Access Compliance Report

Public Rights-of-Way

(Pedestrian Signals)

Intersection ID: N/A	Main Street:	Cross Street: N/A	Location: N/A
ADA ID: 6B2C689EE0CC	Signal Type: One Push Button-Non APS	Overall Compliance: No	Severity Score: BTN 1: N/A BTN 2: N/A No BTN: N/A
Codes/Mitigation Info/Possible Solution		Field Measurements/Component Compliance

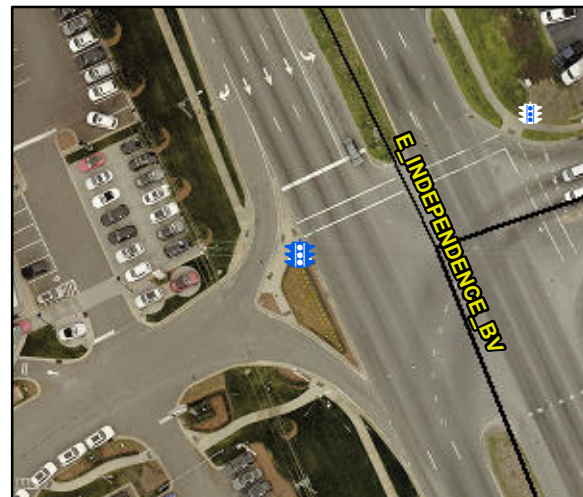
Possible Solutions: Replace Signal Push Button With APS Button on New Post. Remove & Relocate Sign.

PROW/ADA: TMUTCD 4e.08, R404.3, R404.2, R404.7.1, R404.7.2
